**Alcoa of Australia
Limited**

**Attachment 3B: L6465/1989/10
Amendment Supporting
Document**

September 25

Figure 2-1 Noise Mitigation Works

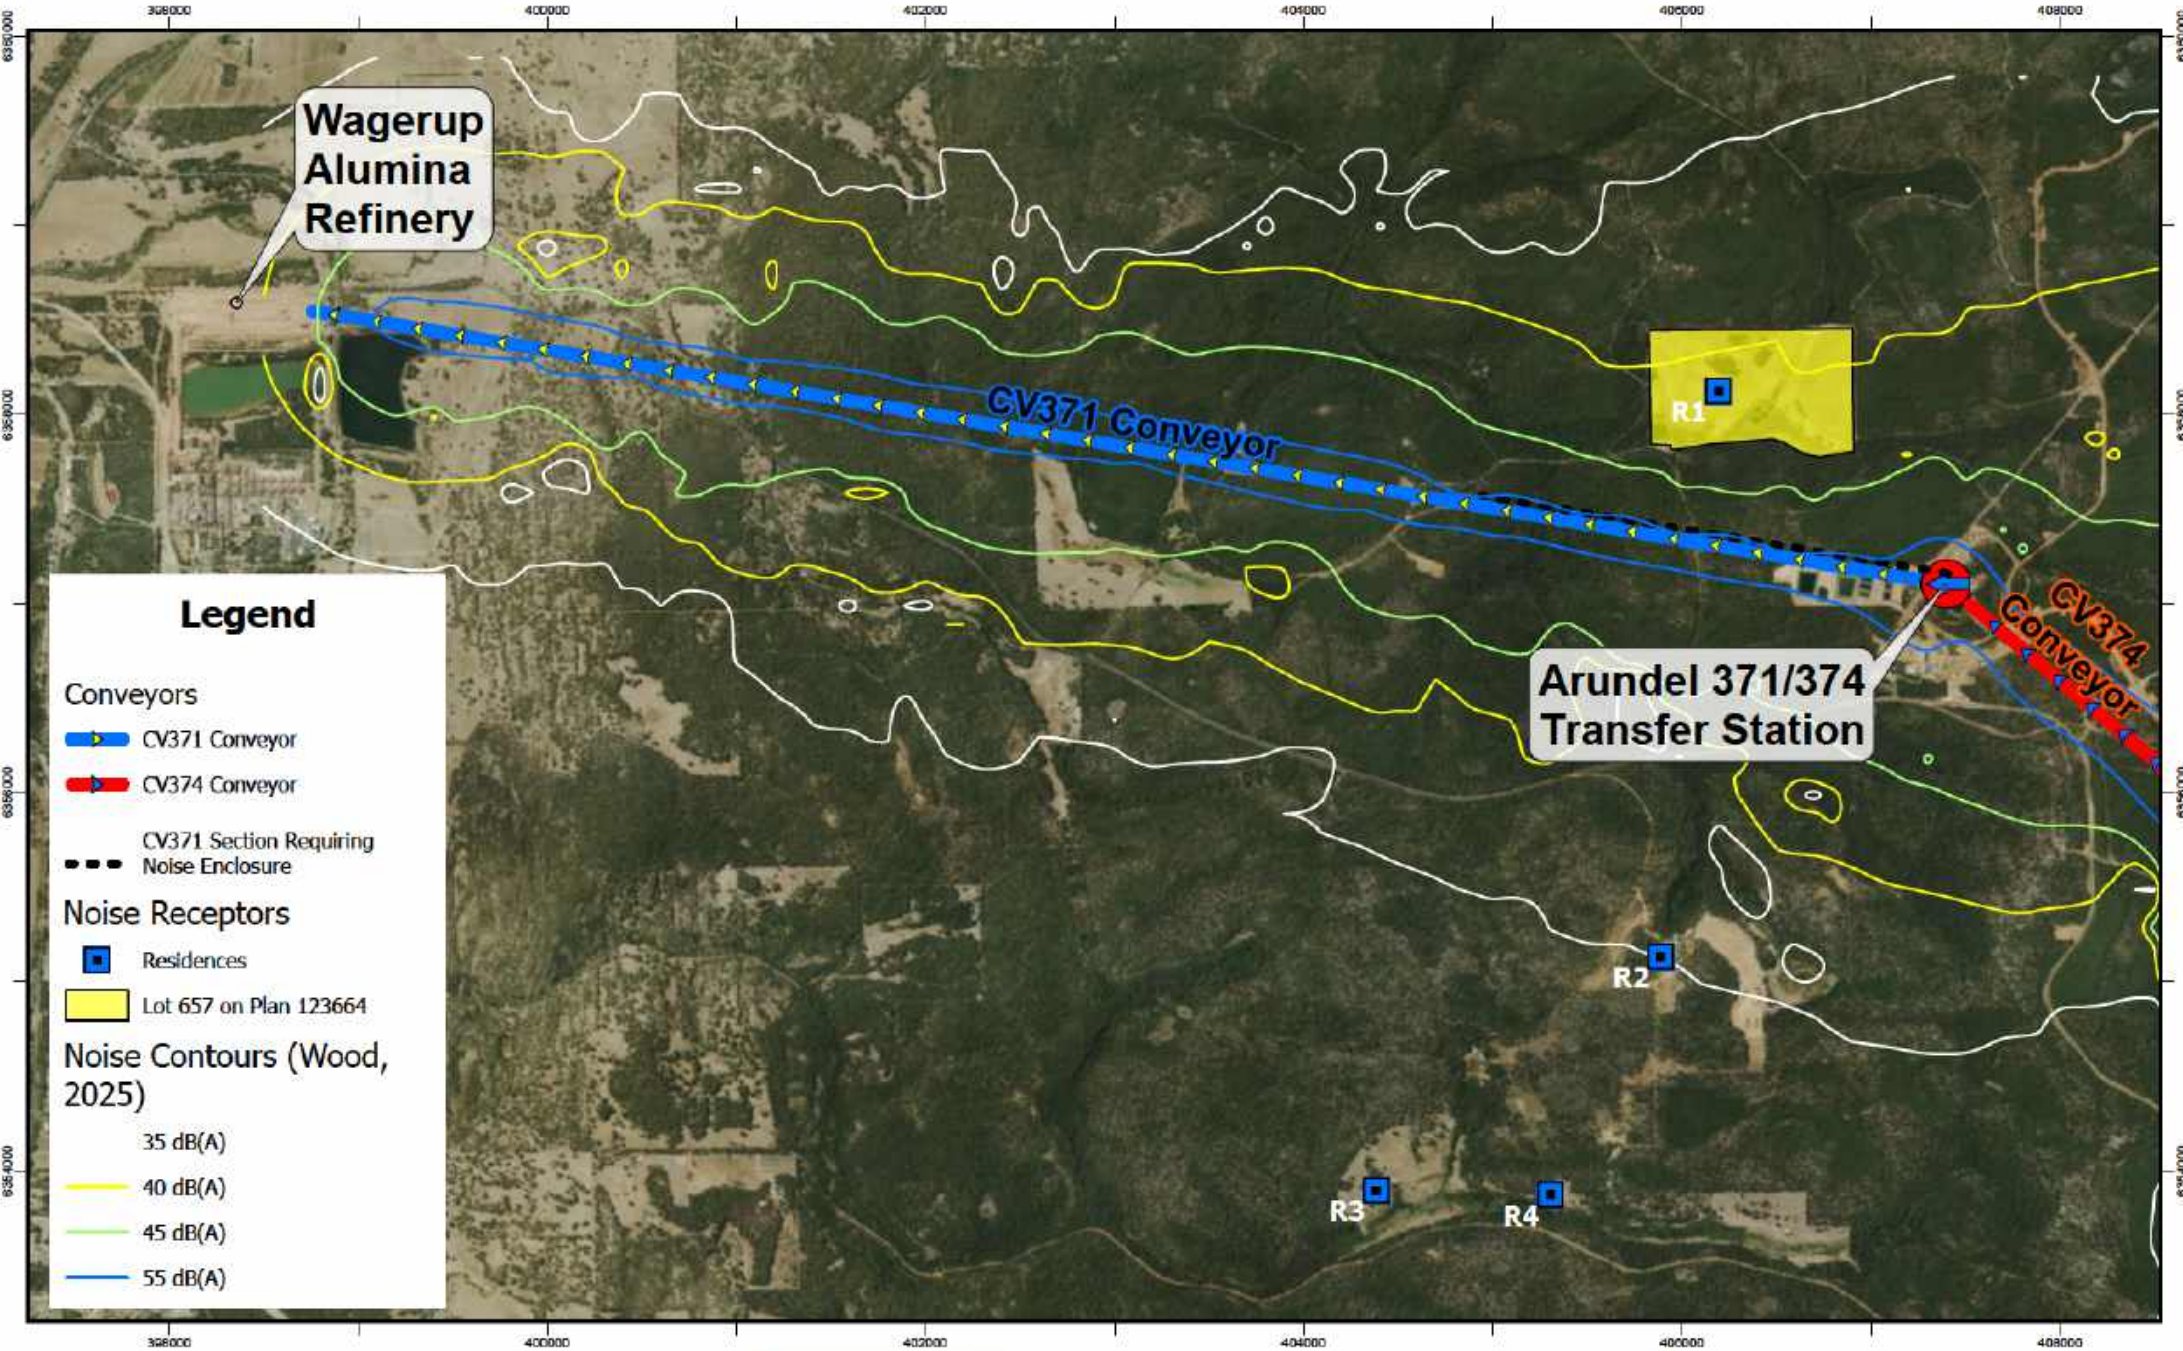
The Noise Mitigation Works have been partially completed. The gaps between acoustic panels at the Arundel Transfer Station have been sealed; however, the Noise Enclosure has not been installed. Completion of the Noise Mitigation Works means installation of the Noise Enclosure.

R1 and the location of Noise Mitigation Infrastructure are shown on Figure 2-1.

A copy of the assessment (Wood, 2025) is attached as Appendix 1. Noise receptors and modelled noise contours under worst-case conditions are shown on Figure 2-1. The contours on this figure include noise from both fixed and mobile equipment.

Predicted noise at receptors from fixed plant only and from fixed plant and mobile equipment are provided in Table 2-1 and noise contours (from fixed plant and mobile equipment) are shown on Figure 2-1. The results show that:

The sealing of gaps at the Arundel Transfer Station has been completed and, with the change in status of R1, completion of the Noise Mitigation Works via construction of the Noise Enclosure is not required to ensure that noise at receptors complies with the assigned levels in the Noise Regulations. Alcoa proposes that:

- The Noise Mitigation Works in Table 1 of condition 1 are removed.
- The compliance and reporting requirements in Conditions 6 to 9 are removed.

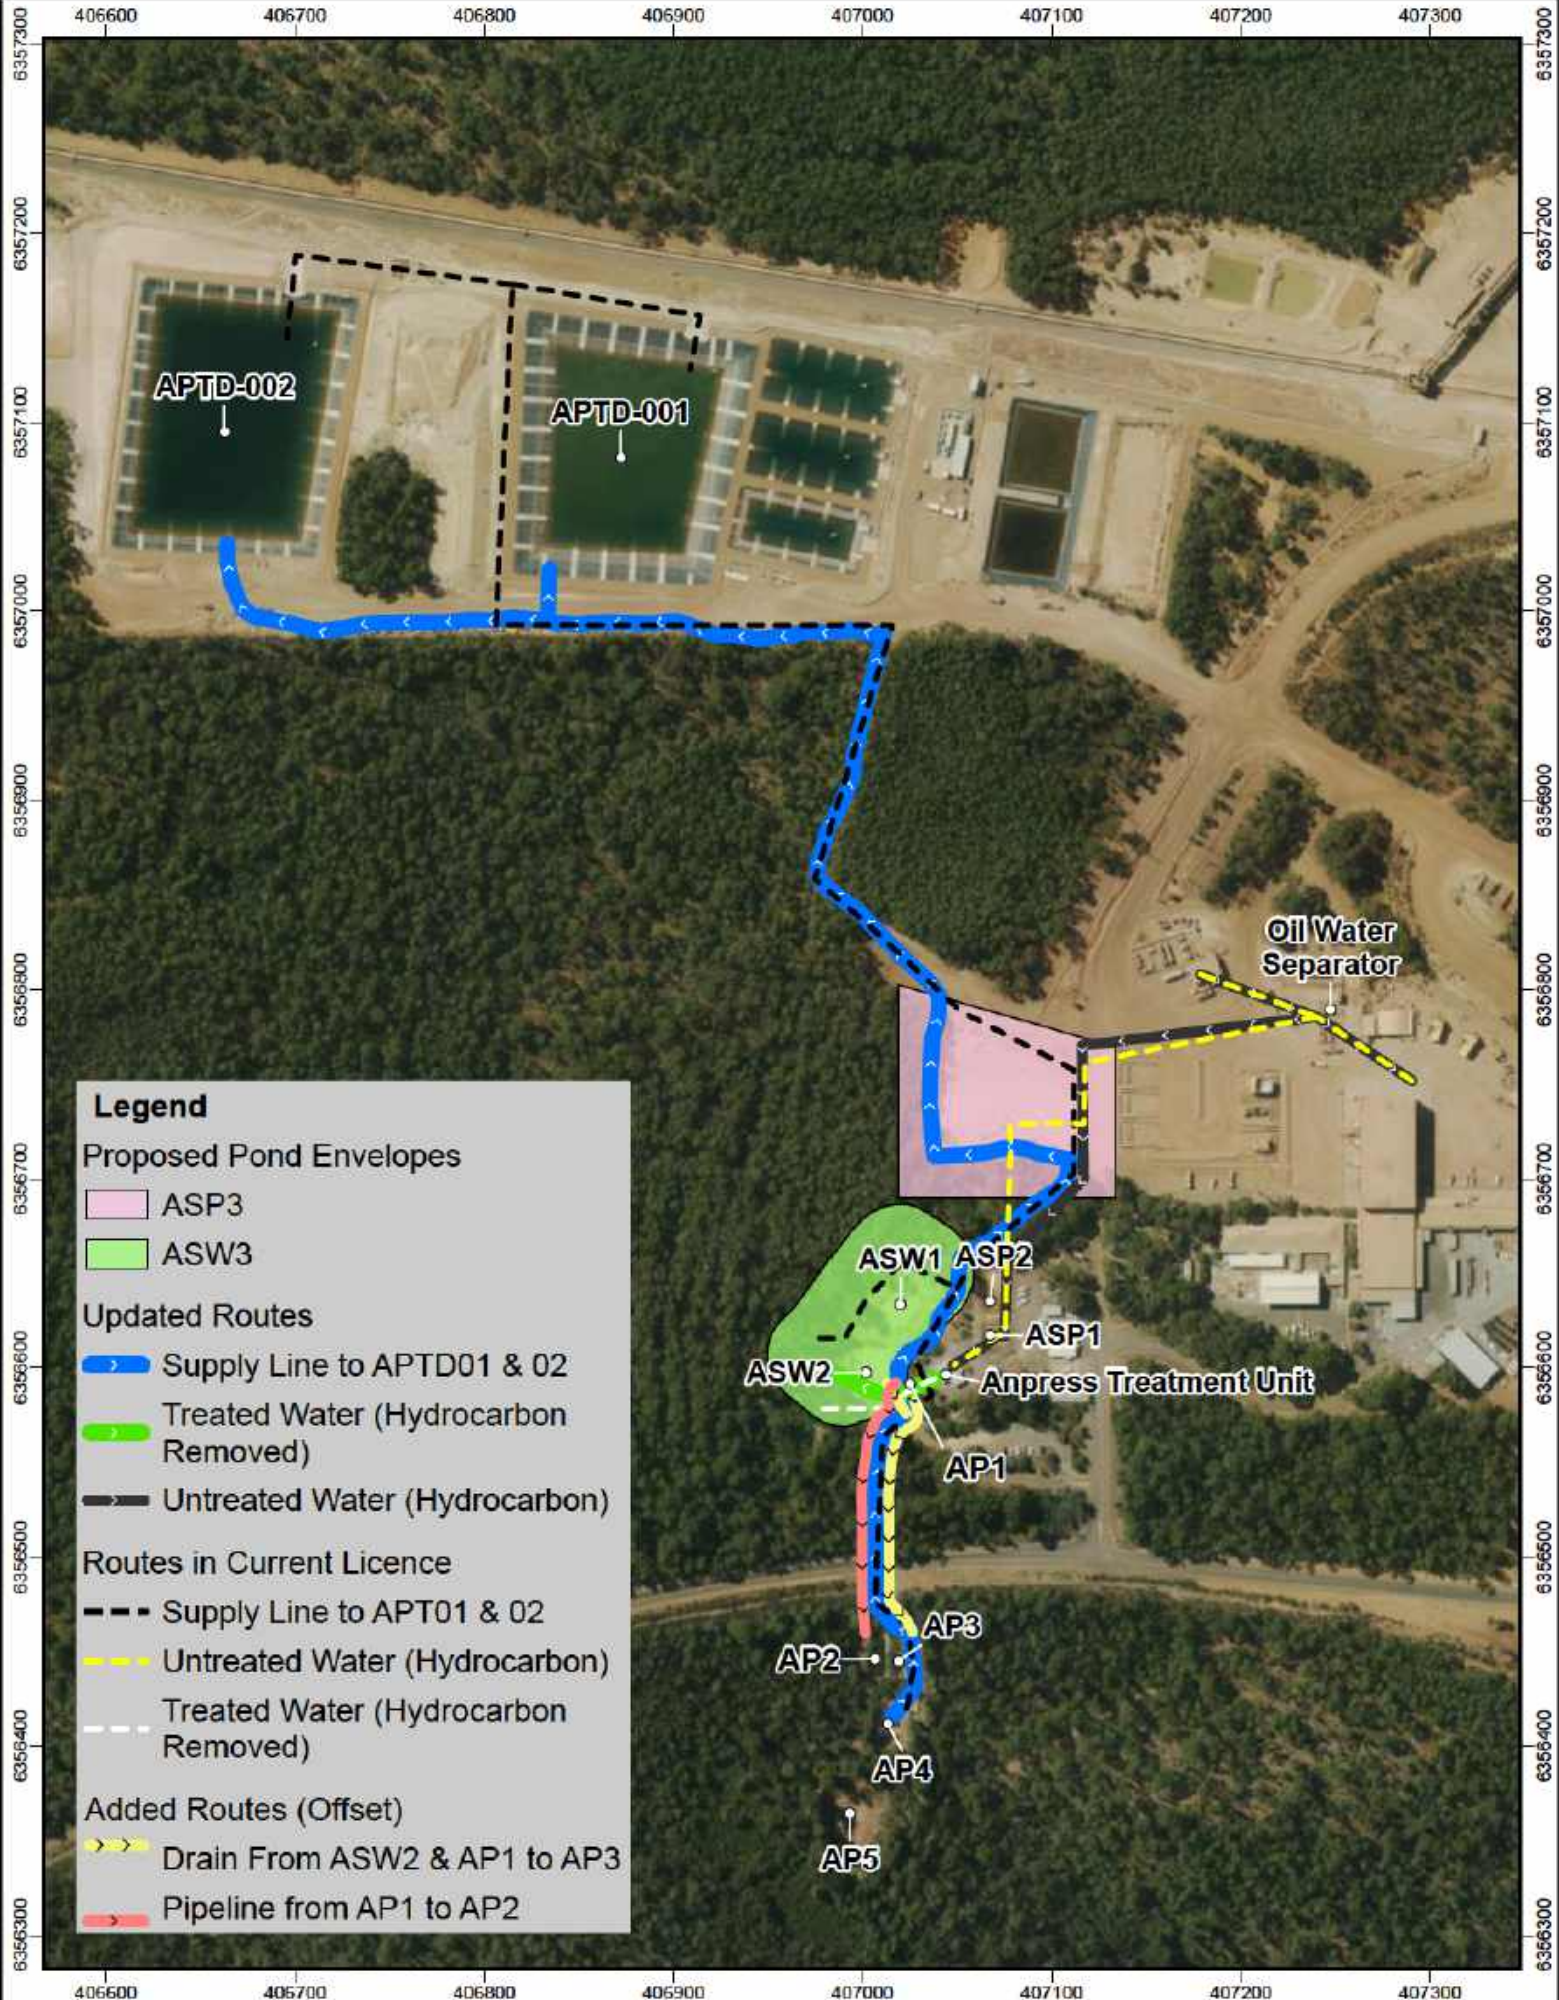
Figure 11 and Figure 12 of the licence show stormwater and treated water at Larego being directed further east than is the case. Alcoa proposes that a shorter route is shown on the figures. The proposed change is shown on Figure 3-3 and has been included in the amended figures for the licence (See Section 7).

Figure 3-1 Updates to Arundel Area

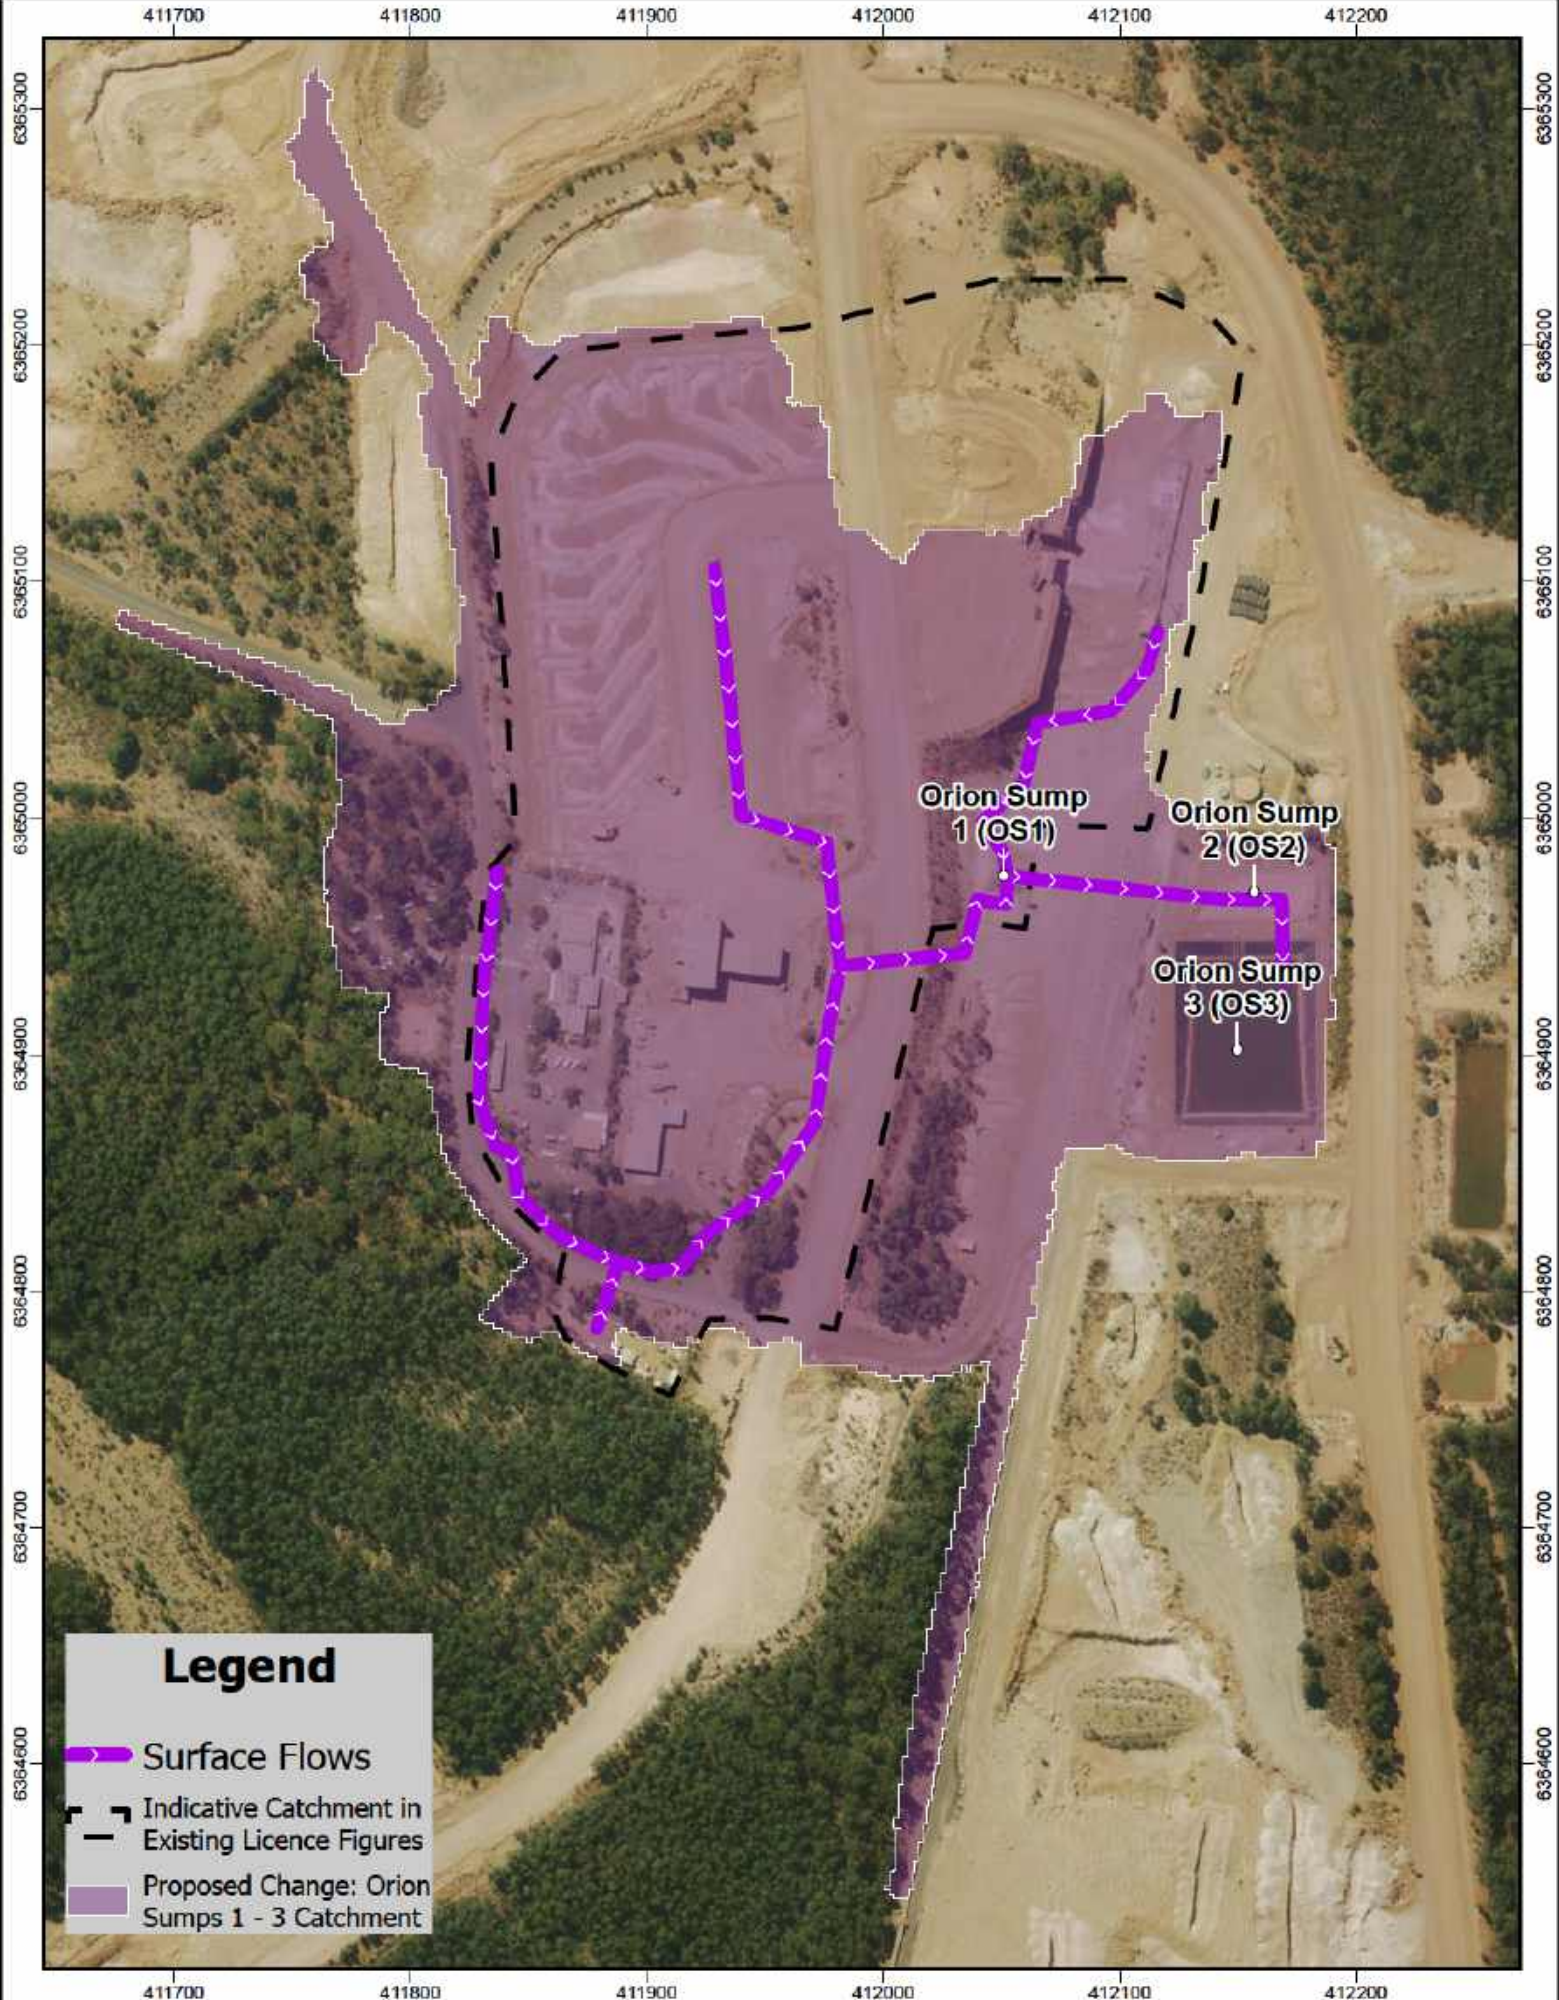
Alcoa has reviewed the pipeline routes in the Arundel area. The routes presented in the Licence Figures 8¹ and 9 do not fully align with the as-constructed routes:

- Supply line to APTD001 & 002, from AP4 to APTD001 & APTD002. This pipeline was constructed in existing easements in accordance with licence conditions. Alcoa requests the figures in the licence be updated to match the as constructed route provided in the compliance assessment report submitted to DWER on 14/02/2025.
- Untreated Water (Hydrocarbon). The alignment of this existing pipeline depicted in the Licence figures does not accurately reflect the as constructed alignment. Alcoa requests the figures in the Licence be amended to more accurately reflect the actual route.

The following routes have also been changed based on the proposed new location of ASW3 (See Section 4.1).

- The section of Supply line to APTD001 & 002 from ASW3 to APTD001 & 002 is proposed to be removed as it no longer leads to the proposed location of the ASW3.
- The route of the Treated Water (Hydrocarbon Removed) Pipeline, from AP1 to ASW3 has been adjusted to the new location of ASW3.

For completeness, Alcoa also proposes that the following existing routes are shown on the licence figures:

- The pipeline that passively flows from AP1 to AP2.
- The drain that flows from AP1 and ASW2 to AP3.

The changes from the existing licence figures are shown in Figure 3-1. Note that the added and corrected routes are shown in all other figures, including the amended figures for the licence (See Section 7).
